TECHNICAL BULLETIN #8 1980

Item #1 Ripcord Recall:

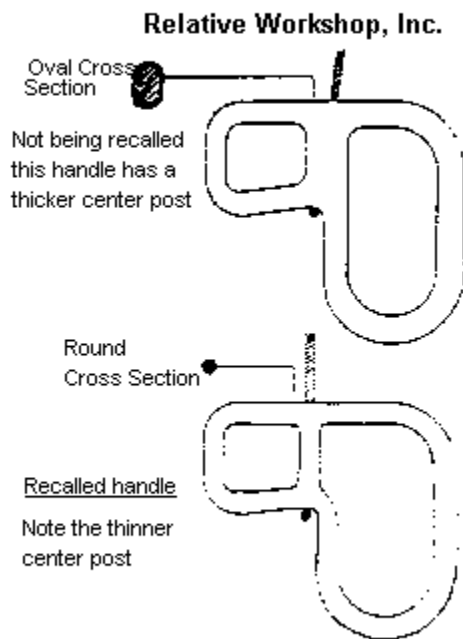
Wonderhog owners that have the type of ripcord being recalled (see diagrams below) should send the entire ripcord to the Relative Workshop together with the following information: the name and mailing address of the owner; the serial number and date of manufacture of the rig (this information is on the TSO tag that is tucked behind the back pad at the top of the container); the name of the person or dealer from whom the rig was purchased, and whether the rig was purchased new or used. For Wonderhog owners who are not able to supply the above information, or obtained plastic handles from another source, such as blast handle conversions, the Relative Workshop will provide replacement ripcords with a metal handle for \$5 if they return the old ripcord.

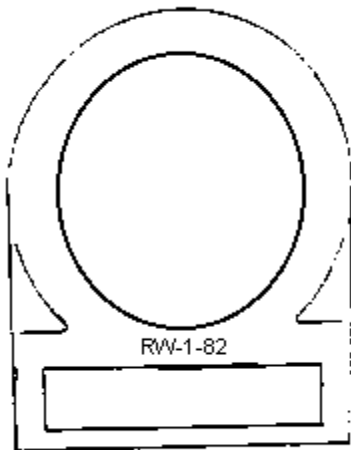
**To make it easier to replace rings on rigs we have designed a separable RW-1 similar to a normal separable D ring. All that is required is a bolt cutter and a screw driver. No stitching is required.

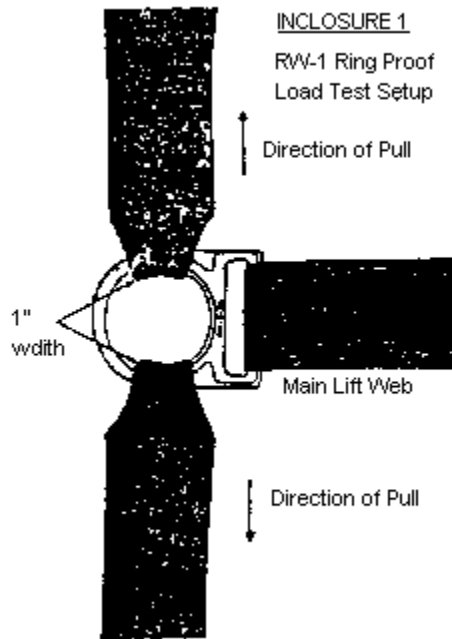
2) Subject each load to a 2,500 pound (1134 kg) proof load. Measure the internal diameter of the large ring prior to testing with a micrometer at eight points around the circumference; load the ring to 2,500 pounds, relax the load, and remeasure the ring at the same eight points. Rings which show no deformation more than 0.020 inches are acceptable. Any ring showing deformation more than 0.020 MUST BE REPLACED. (Note #1: defective rings will noticeably distort when loading reaches approximately

2,000 pounds (907 kg) and stay distorted when tension is relaxed. Note #2: If pull test is conducted using two metal bars in place of webbing loops and test is conducted at 90 degrees to normal hardware loading (as shown in drawing), then a 2,500 pound may stretch normal good hardware. Therefore a 2,000 pound load will be sufficient to certify a ring as good in this case.)

3) Harnesses using rings which have been tested and are found to be acceptable, must be designated by permanently affixing a rigger's seal (with symbol) using wire (not red rigger's thread) to the right ring's webbing slot. The seal must be attached to the square portion of the ring through which the main lift web passes, not the round portion.

Item #6 Rapide Links:

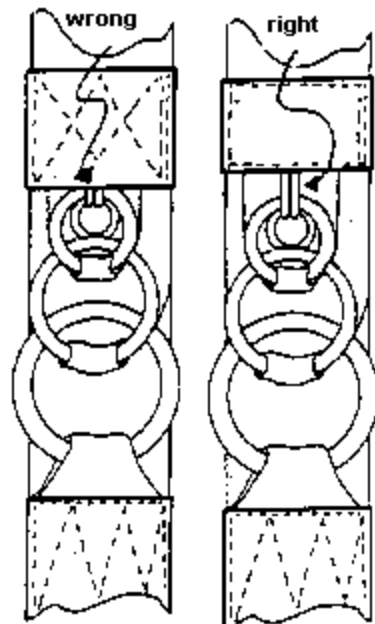
Skydiving pull-tested some half-threaded #5 Rapide links to destruction several weeks ago to determine exactly how strong these fittings are. The #5 links used on most main and reserve canopies sold today. Many jumpers don't notice that their links are loose until the locking barrel has become half threaded.

Two half-threaded Mallion links failed at 1,700 and 1,800 pounds respectively. (Mallion manufacturer's bonafide Rapide links although cheaper clones are commonly encountered.) A half-threaded no-brand link purchased at a local hardware store failed at 1,800 pounds while a properly threaded #5 link withstood a pull-test of 3,000 pounds. It was permanently elongated at the end of the test but it didn't fail.

One way to prevent links from unthreading is to force a piece of 3/4 inch I.D. clear plastic tubing (available at many hardware stores) over the link. The tube also protects the slider grooves from sustaining damage when striking the links. But some jumpers worry that control lines can jam between the slider and the bumper causing serious problems at low altitudes. The problem may be aggravated when #5 grooves are used in the slider instead of the larger #8 grooves.

Item #8 McLachlan Parachute Equipment "RACER":

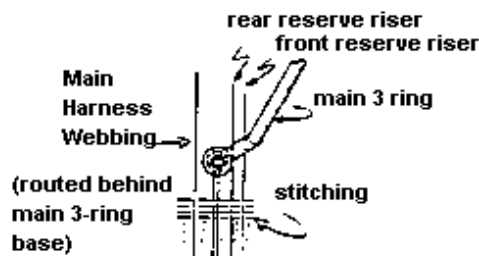
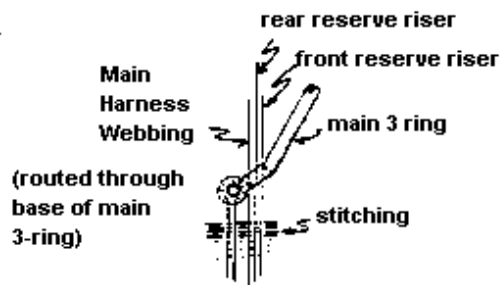
A serious design fault has been detected on a system manufactured by McLachlan Parachute Equipment (NZ) Ltd. The system involved carries the name "Racer" and is a copy of the SST Racer manufactured in the USA.

The problem involves the routing of webbing through the large 3-ring on the harness and the positioning of the main risers (see diagram). The system was test dropped by an independent testing authority under APF (Australian Parachute Federation) supervision. The test drops were carried out to the design standards approved by the Department of Aviation. The drops simulated the forces that would occur during a parachute opening sequence.

FAULTY CONSTRUCTION

CORRECT CONSTRUCTION

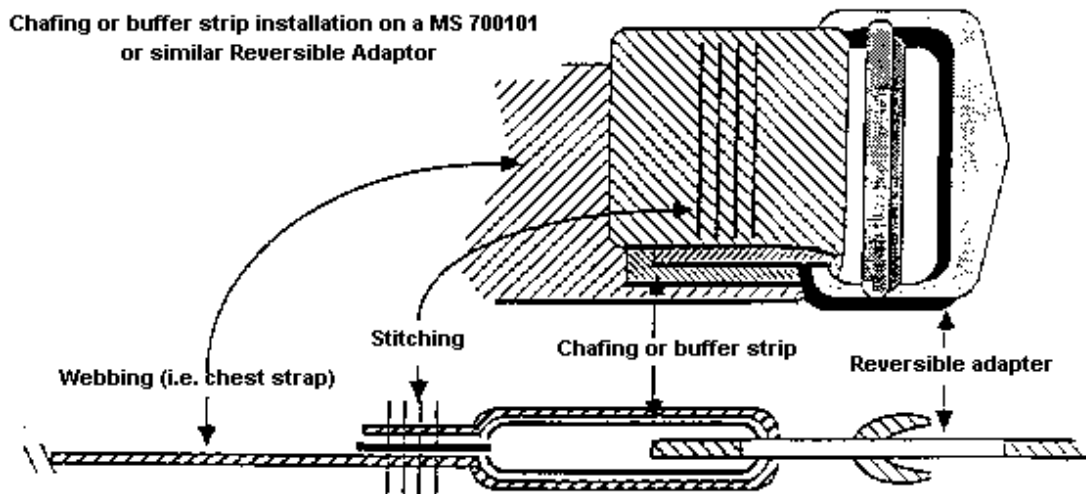
It has come to my attention that the MS70101, light weight reversible adapter, is being sewn onto webbing without the use of a "buffer" strip on the sewn side.

We have spent a lot of money on our tooling trying to keep the sharp edges in this part to a minimum. Since it is a stamping and is already very thin, by its very design it tends to be abusive to the webbing

All stamped parts should only be used with a "webbing buffer" on the sewn side to prevent abrasion and cutting. The buffer strip can be any kind of webbing which is thick enough to increase the radius of the edges and provide some protection to the sewn webbing

When installing buffer strips, either leave them long enough to have the "tails" caught in the regular stitch pattern or sew them on the webbing with a bar tack or a regular stitch pattern.

Left Side

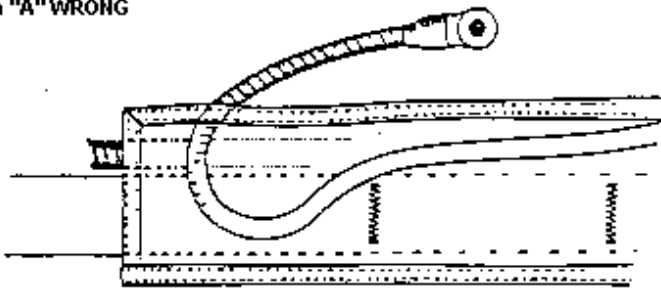
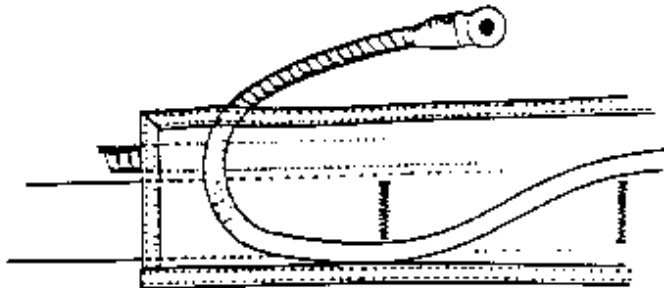
Diagram "A" WRONG

Note: The proper distance for the housing to stick out of the pad is 4.5" to the centre of the eye for standard rings and 3.75" for mini rings.

Diagram "B" RIGHT

Safety Warning Notice
 MISUSE OF RW-2 RING

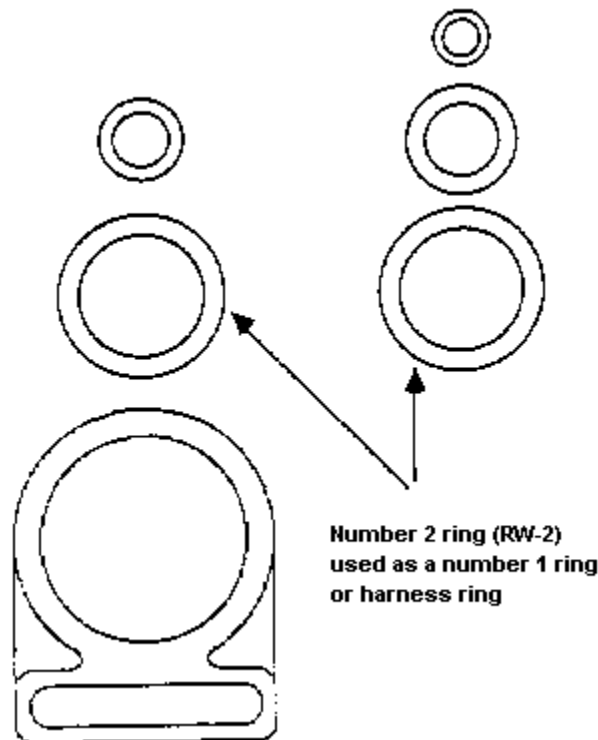
It has come to our attention that some manufacturers are using the RW-2 ring as the number one ring in a "mini" ring system. This ring was not designed for this purpose and could deform and cause a malfunction. If you are going to install a mini ring system on a rig, it should only be done using the "D" shaped ring number one ring such as the RW-7 from 3-Ring Inc. or the French mini "D" ring.

The RW-7 ring has a proof load of 2,000 lbs (900 kg) and the RW-2 has a proof load of 500 lbs (227 kg). The RW-1 ring carries a proof load of 2,500 lbs (1127 kg).

Since the first ring in the 3 Ring system gets most of the load, we consider the use of any ring not designed and intended for this use to be improper and unsafe.

Item #2 Northern Lite III main pilot chute in tow:

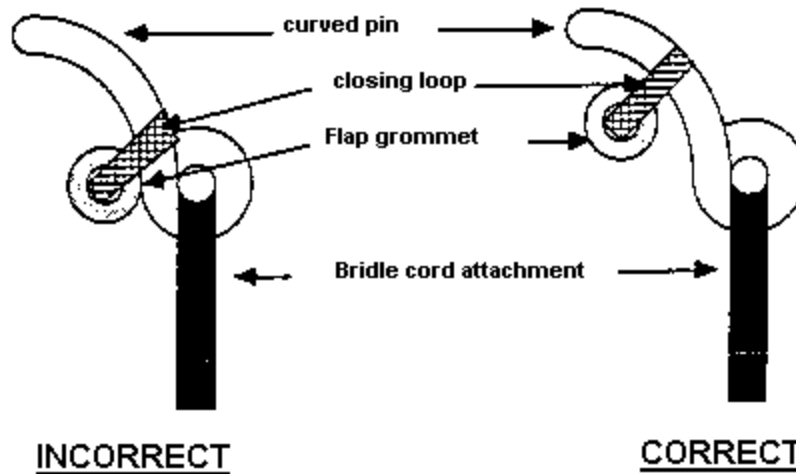
A series of pilot chute in tow malfunctions reported to Para-Phernalia, Northern Lite III manufacturers, has been attributed to the curved pin being buried in the main closing loop.

The manufacturer indicates that it is mandatory that the curved pin not be buried and that the pin position be adjusted so that the closing loop is midway on the curved pin (see diagram below).

Item #1 RAPIDE link damage:

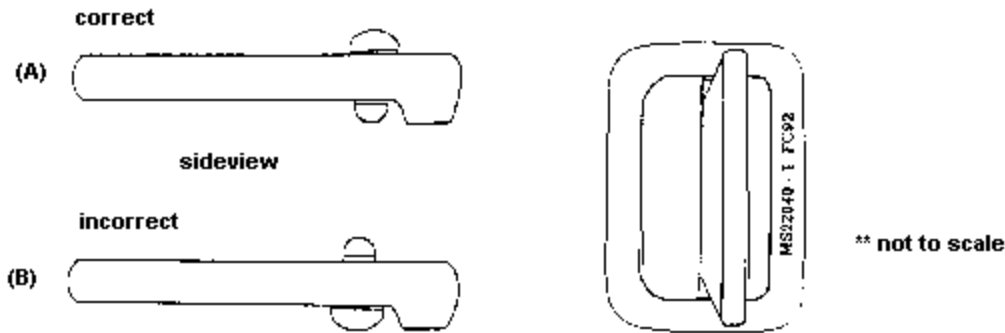
There had been several reports of unexplained main suspension line breakage. This breakage had been reoccurring on the same canopy type which indicated there may be reasons other than wing loading causing this damage. Upon closer inspection by a rigger it was found that whomever had installed the canopy to the main risers probably had used pliers or vice-grips to assist in holding the Rapide Links for tightening. This resulted in scoring of the links thereby creating a "cutting" action on the lines during opening.

Think of the possible consequences if this method were used while installing a reserve canopy to risers.

Item #3 Bulletin from THOMAS SPORTS EQUIPMENT (TSE):

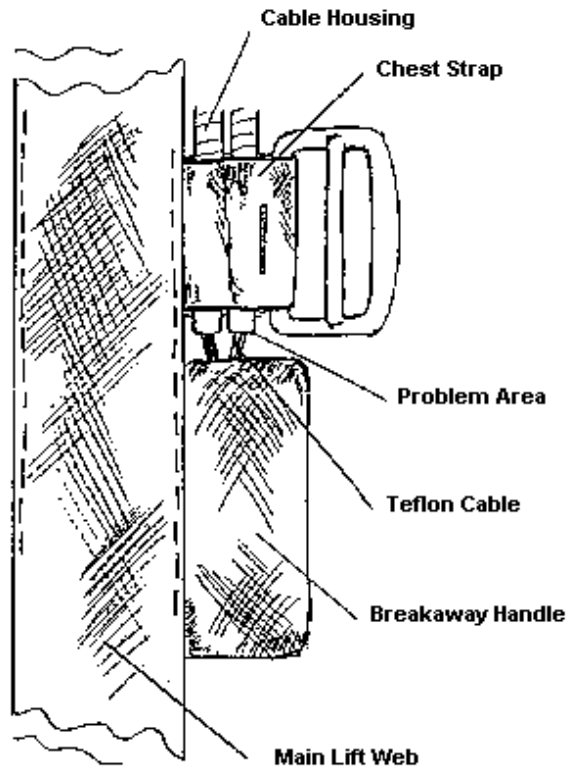
Inspection of some older models of Tear Drop H/C has revealed excessive wear in the area of the small washer which retains the reserve loop. Also, wear has been noticed on the loop where it passes through the grommet of the metal "pop-top" plate. This damage may have occurred while packing the reserve.

There has been a number of premature reserve deployments on T.S.E. One Pin Tear Drop Reserve Containers. Containers with the small "old-type" washers and loops should be changed to the updated "Cypress" type of washer/loop combination. A qualified rigger can perform this loop change without repacking the reserve.

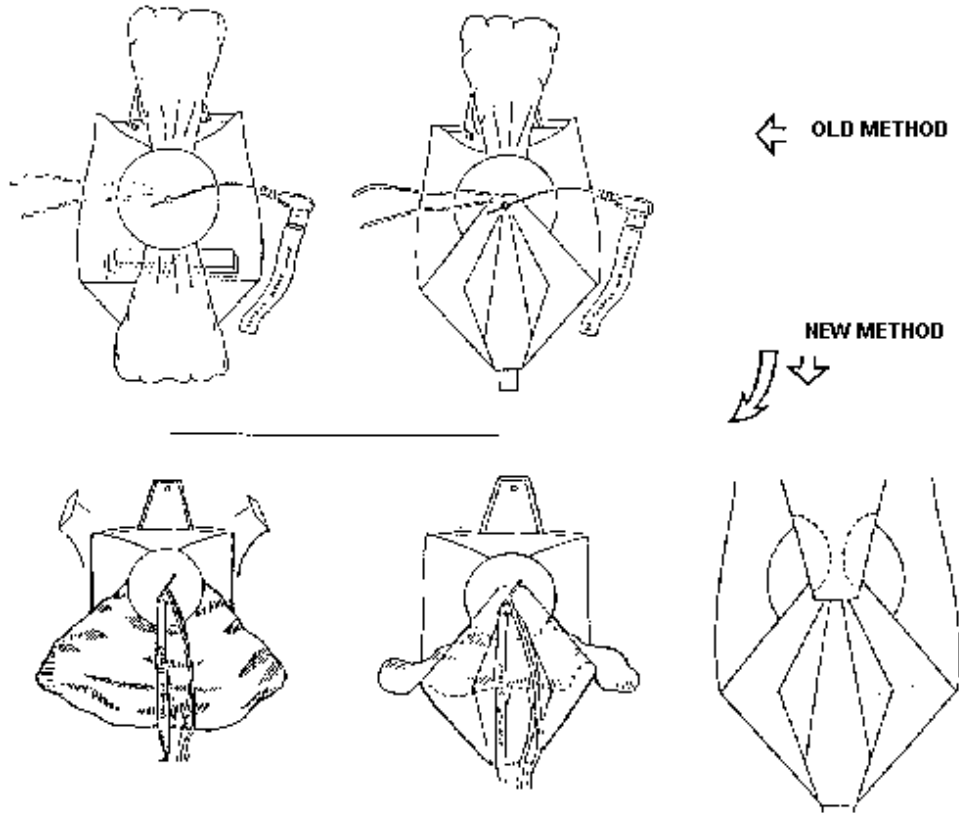
It was found that some riggers, when using the old method of stowage, would sometimes not only tuck the pilot chute fabric under the top flap of the reserve container but also into the cavity between the freebag and the top flap. This could result in the pilot chute in properly launching or even failure to deploy.

The revised instructions tell the rigger to follow the same basic steps except the pilot chute fabric is rolled and positioned differently; most of the fabric ends up under the bottom flap.

Item #6 PARA-FLITE service bulletin No. 9401:

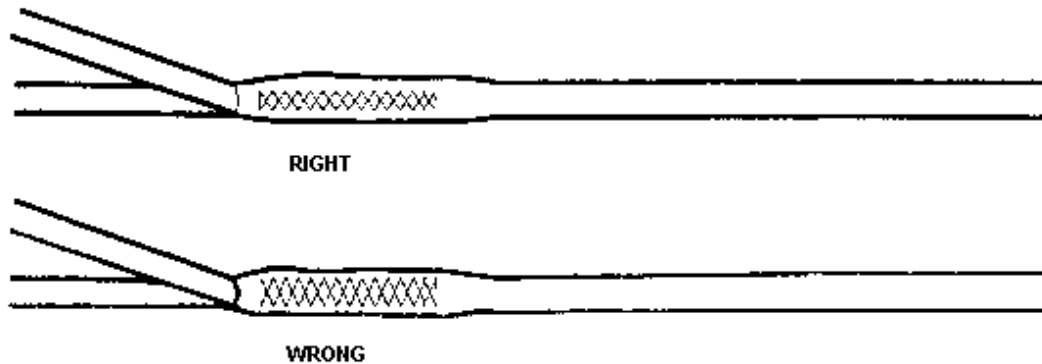
A bulletin which demands compliance at the next repack cycle, but not later than 150 days after the issue date of January 3, 1994, affects Swift Plus reserves with Spectra lines.

A Swift Plus reserve was found to have a faulty bartack at a D line cascade. The width of the bartack was too wide to catch the finger trapped in position of the cascade, which allowed the cascade to be pulled free by hand.
